### ARCHITECT'S SUPPLEMENTAL INSTRUCTION NO. 6

DATE: March 13, 2024 PROJECT NO: 230117

RE: Streets of West Pryor - Lot 5 Core & Shell

A-301

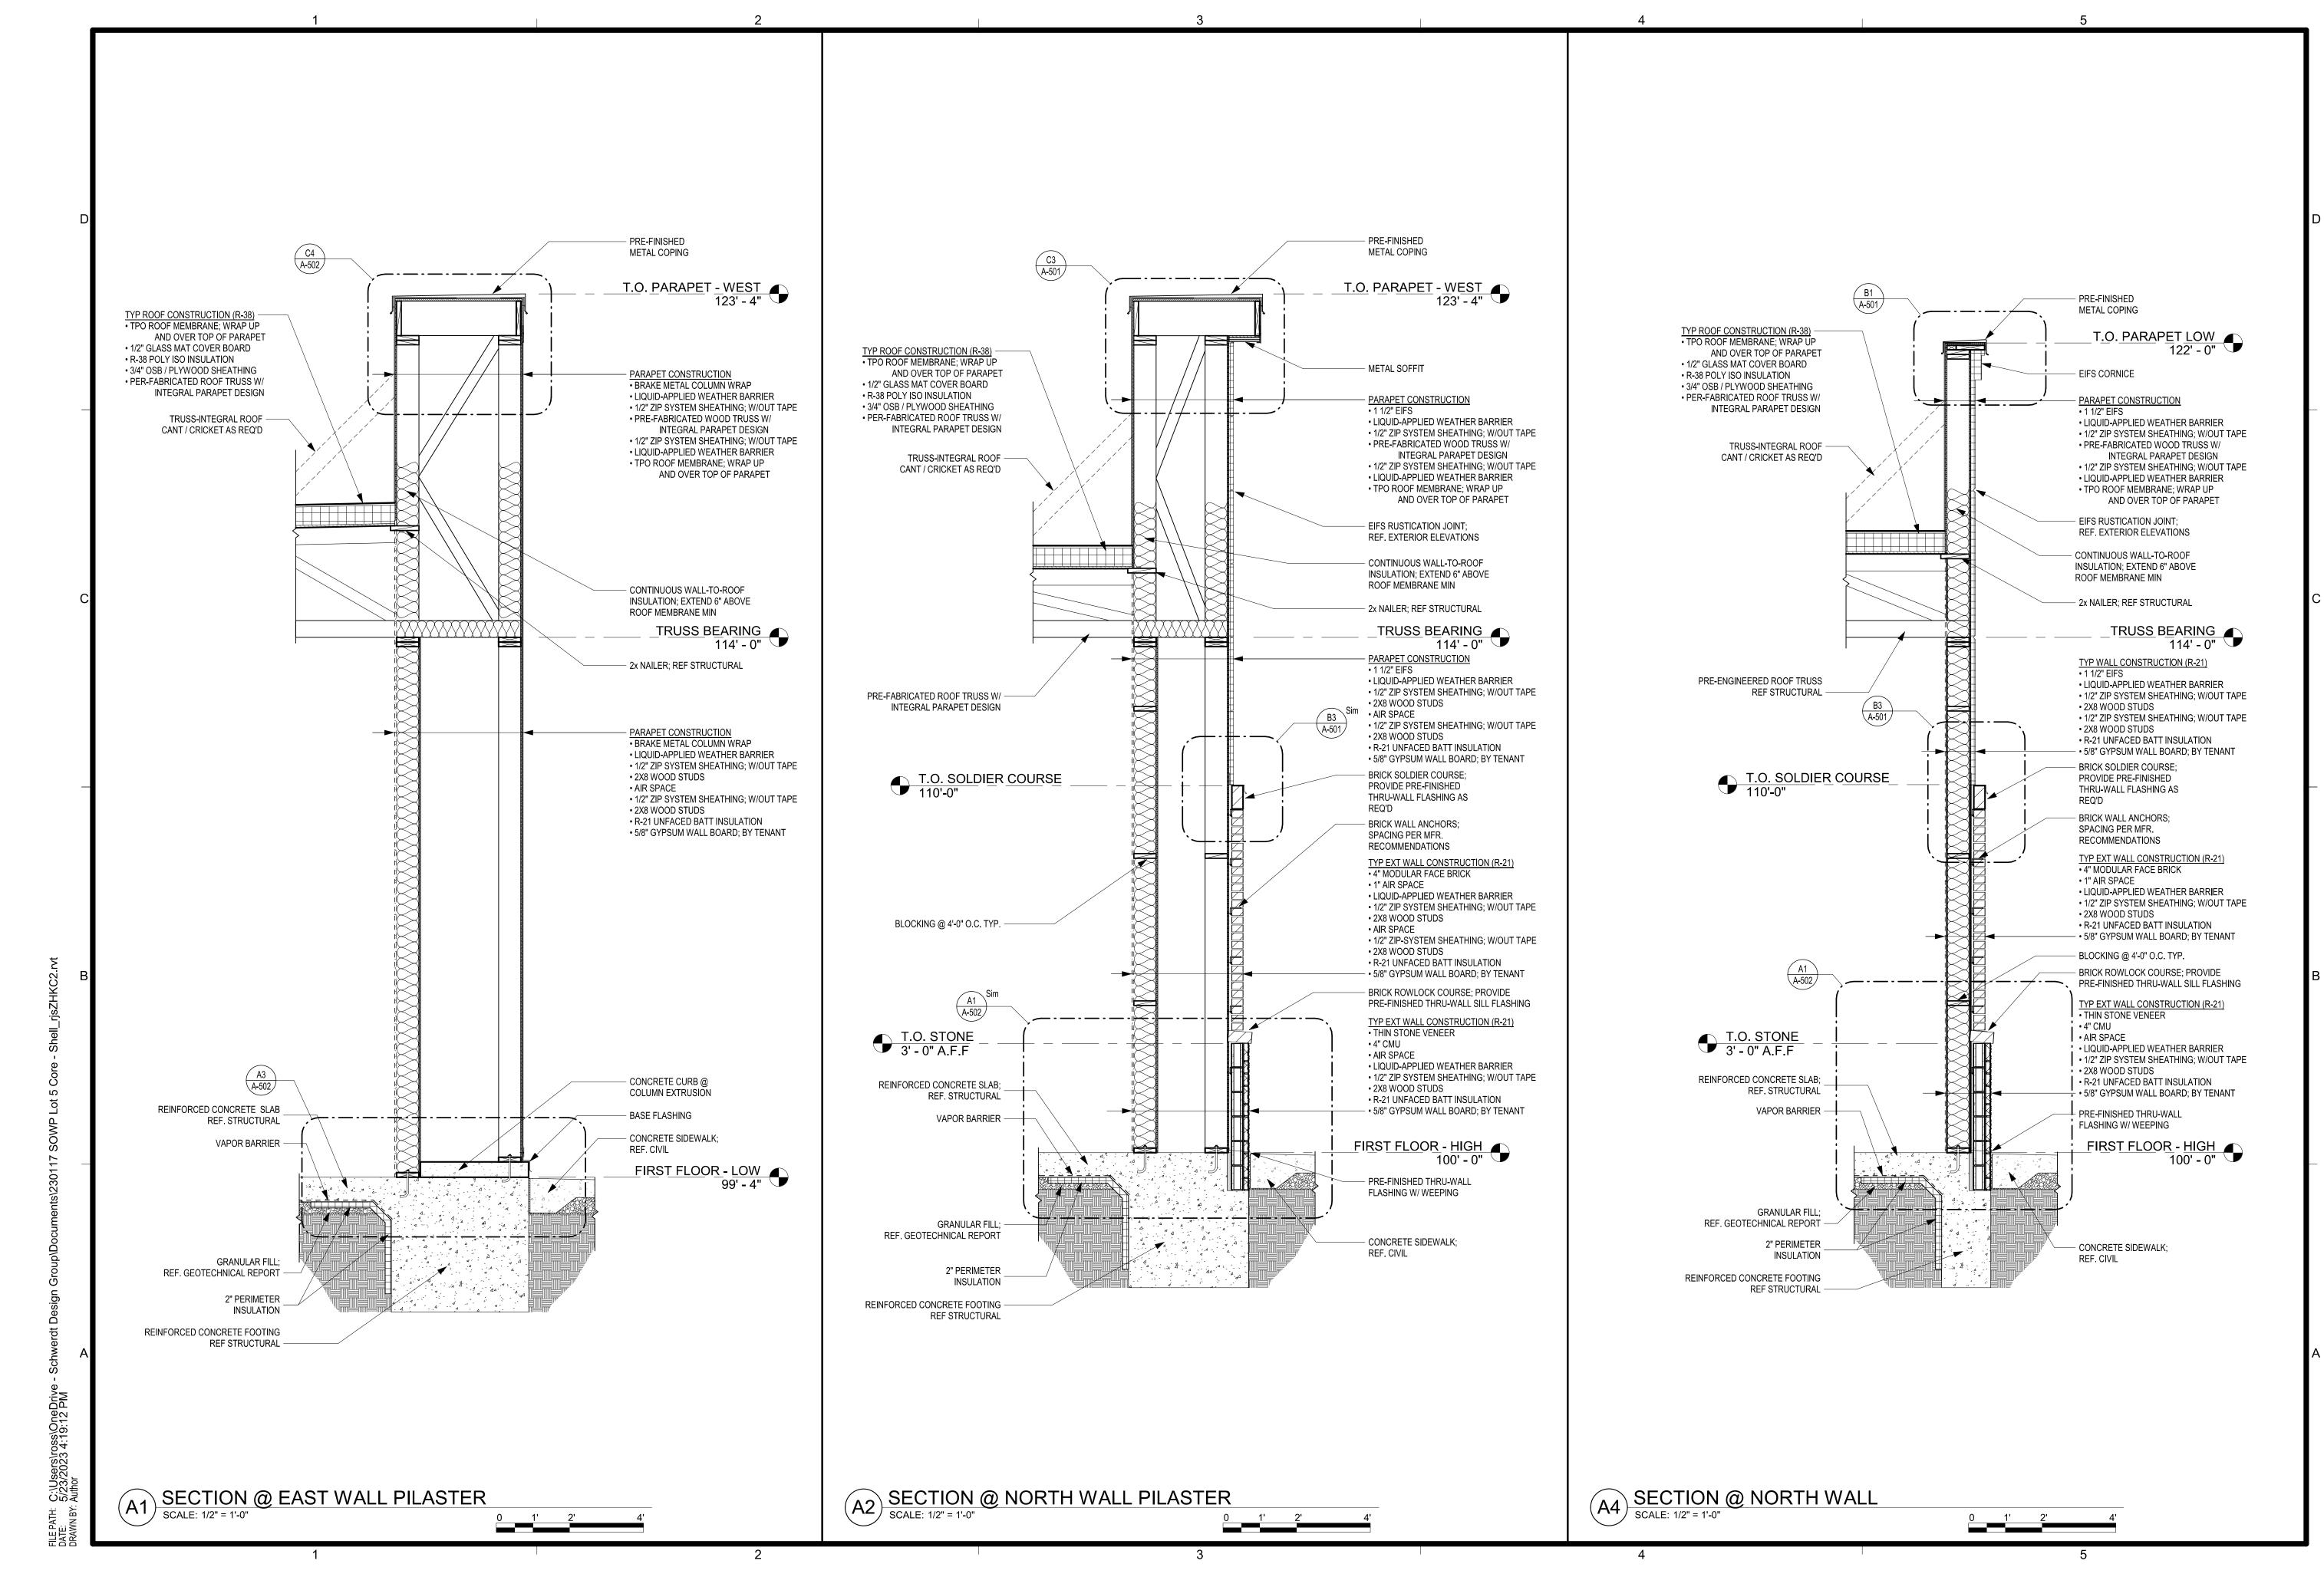
- A-1 Sheet A-101 UL Fire rated wall assembly information has been added to partition type P1.
  - A-1.A Partition types P2 & P3 have been added to partition type legend.
  - A-1.B Partition types P2 & P3 have been tagged in plan.
- A-2 Sheet A-102 Pilaster added to West wall.
- A-3 Sheet A-301 Wall construction updated to clarify horizontal lap aluminum siding.

FOUNDATION PLAN

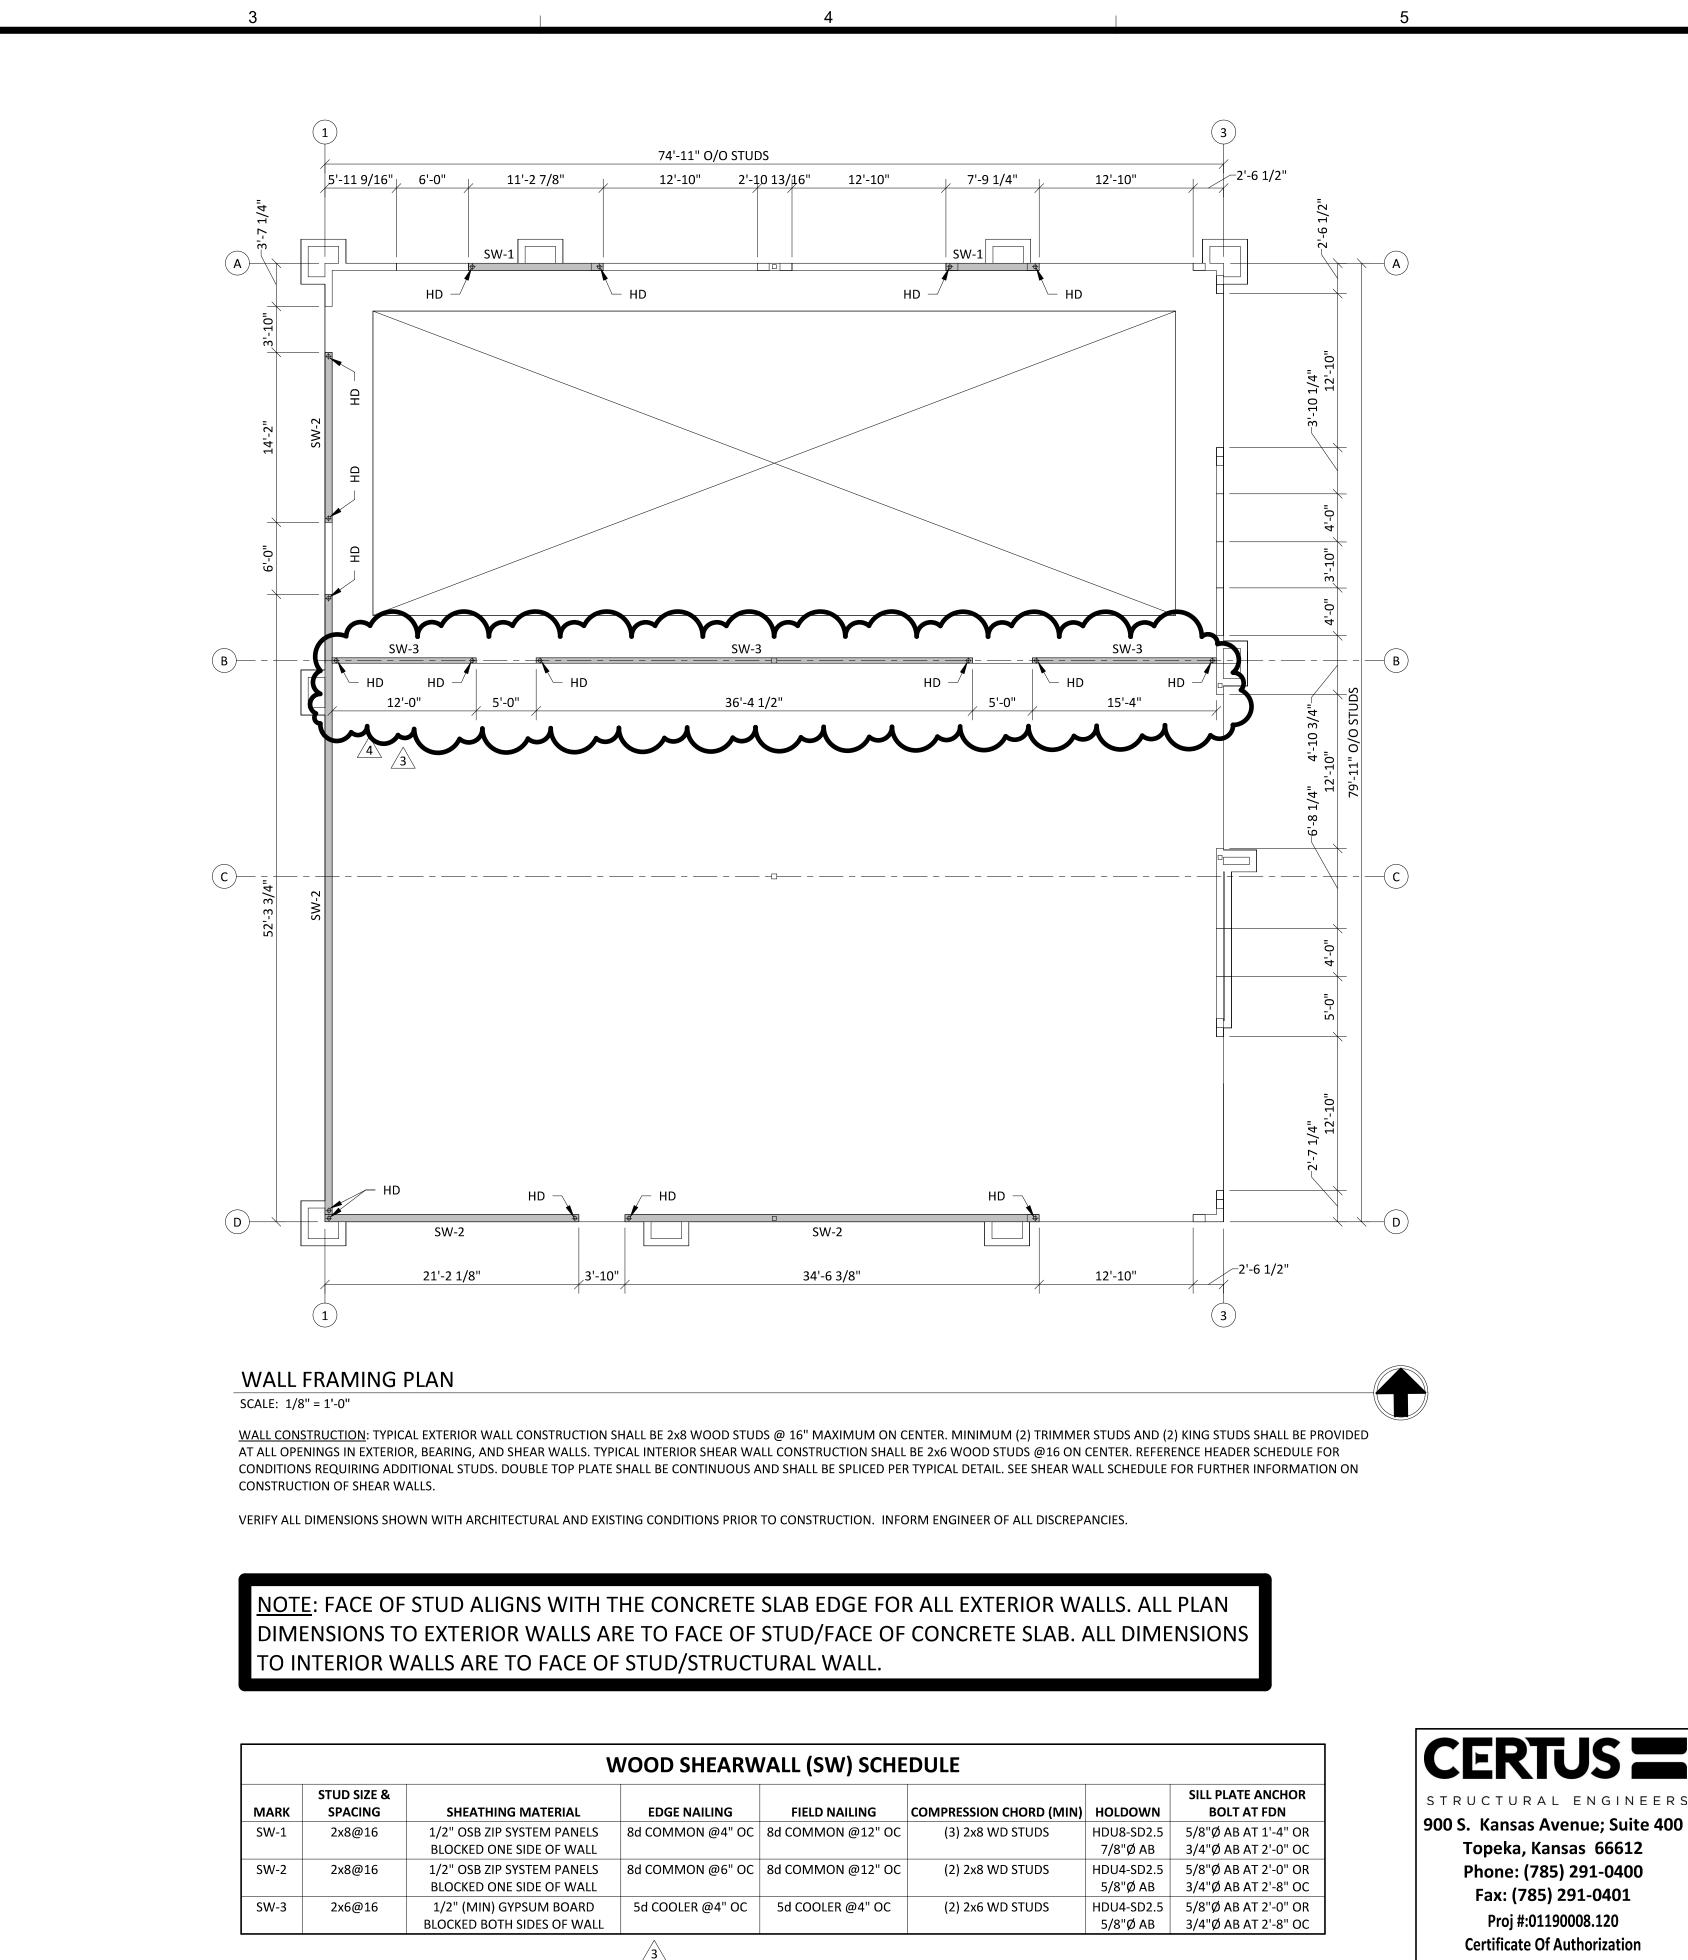
- S-1 Sheet S-001 Updates to general notes Risk Category and Wind Load information.
- S-2 Sheet S-101 Foundation updates to columns B.1-3 & B.9-3 and dimensional spacing on East.
  - S-2.A Addition of West pilaster foundation.
- S-3 Sheet S-102 Future pass-through openings added to shearwall
  - S-3.A Wood shearwall schedule updated.
  - S-3.B Addition of West wall pilaster.
- S-4 Sheet S-103 RTUs rotated 90 degrees for structural support.
  - S-4.A Future pass through openings located in shearwall.
  - S-4.B Addition of West wall pilaster.
- S-5 Sheet S-201 Updated shearwall pass-through openings and west wall pislater added to isometric.
- S-6 Sheet S-301 Bolt type and dimensional location update to Baseplate Details drawings BP-2.

WALL FRAMING PLAN

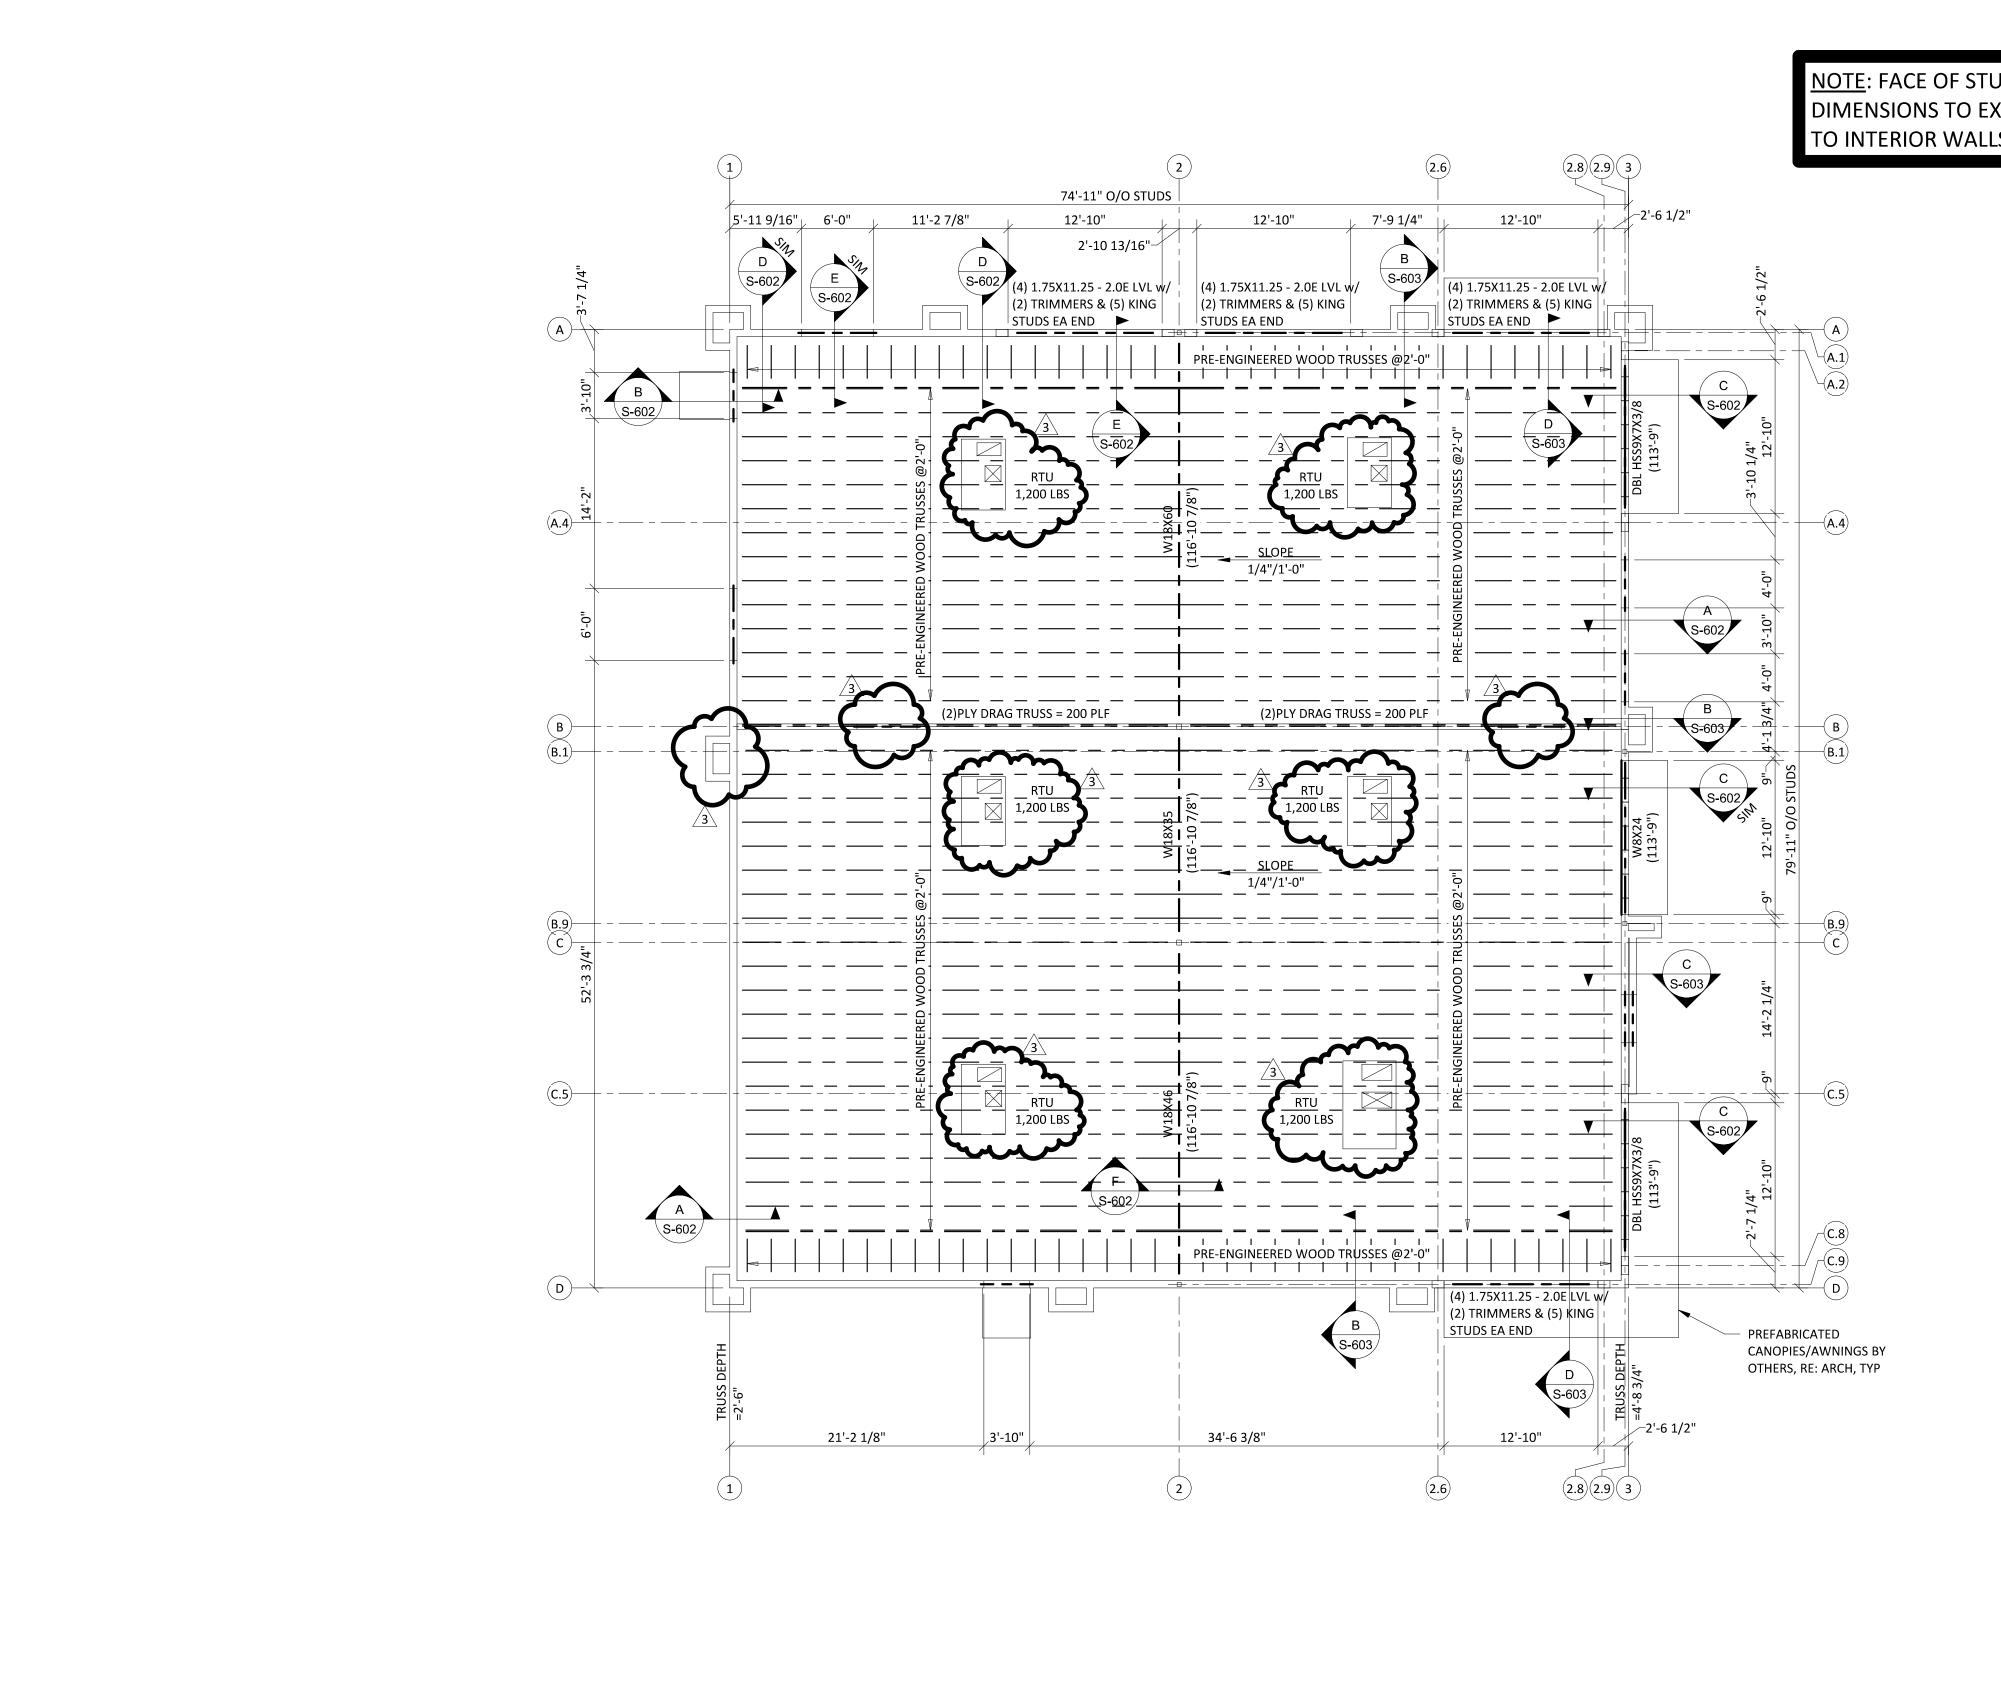
S-1 Sheet S-102 - Updated location of future pass-through openings on Suite C's South demising wall.
